REPORT: March 7, 2016

RE: Domicile Homes Tentative Subdivision Map (S 15-02), APN 015-430-119, Floral Avenue, south of East Avenue and Floral Avenue intersection

RE: **Tentative Subdivision Map S 15-02 Domicile**

S15-02 DOMICILE TENTATIVE SUBDIVISION MAP

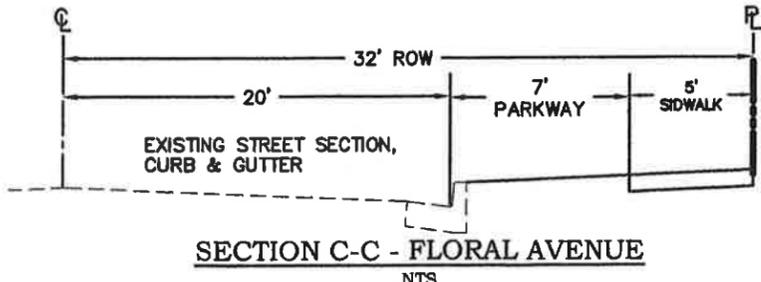
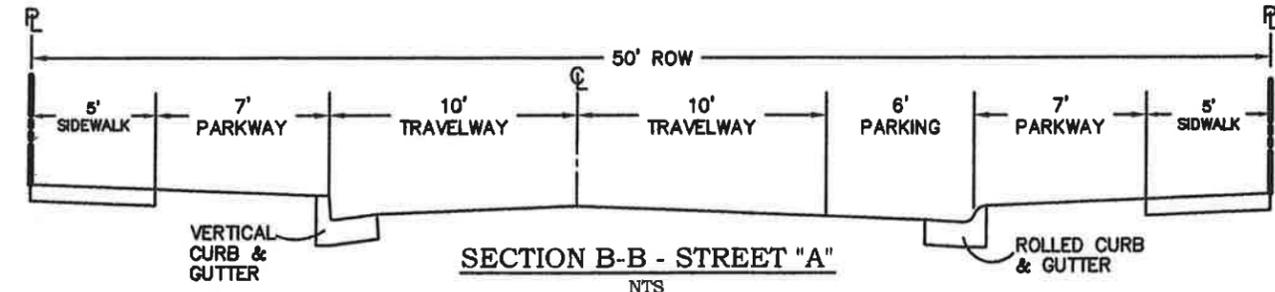
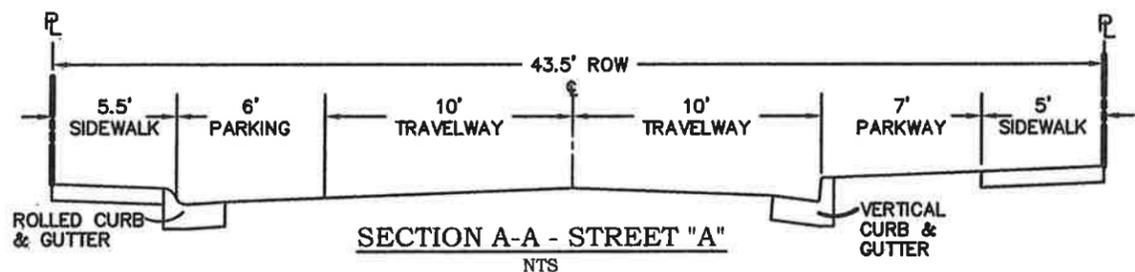
Lots 6 and 7 are flag lots as defined as under Chico Municipal Code (CMC) section 19.76.180 *Infill Residential Flag Lots*, and are subject to development standards that include providing an extra off street parking stall, and limiting the structures height to single story. This code section also requires that proposed flag lots cannot be smaller than existing flag lots located within 300 feet of the project site. Currently, there are 4 flag lots located off Sunflower Court to the east, the smallest being 6,517 square feet. Because lots 6 and 7 (proposed at 6,226 and 6,368 square feet) do not meet the minimum size of 6,517 square feet, staff has placed a condition of approval that will require the map to be revised to meet this minimum lot size.

Because Lot 6 and 7 will be served by an access driveway, staff believes that Lot 8 can benefit from the access driveway, and thereby minimize the number of curb cuts on the street and provided additional on-street parking. Therefore, staff has placed additional condition of approval requiring Lot 8 also take vehicle access from the proposed easement and not to have a curb cut.

One large Oak Tree (No. 6 on attached Tree Matrix), is noted to be saved. The trees location is along the proposed street, and it's retention leads to subdivision design modifications that are noted below. To ensure that this tree is protected during construction, staff has added a condition of approval requiring a tree protection plan to be submitted, and approved, prior to

1. **Request:** Non-standard intersection returns.

2. **Request:** Lot depths less than 80 feet.

3. **Request:** Non-radial lot lines.

4. **Request:** Non-standard typical sections.

5. **Request:** Non-standard horizontal alignment.

12. Lot 6 and 7 shall be revised to be a minimum lot size of 6,517 square feet.
13. Lot 8 shall take vehicle access from the 25 foot easement proposed to the east.

Recommendation: Acceptable.

Recommendation: Acceptable.

Recommendation: Acceptable.

Recommendation: Acceptable.

Recommendation: Acceptable.
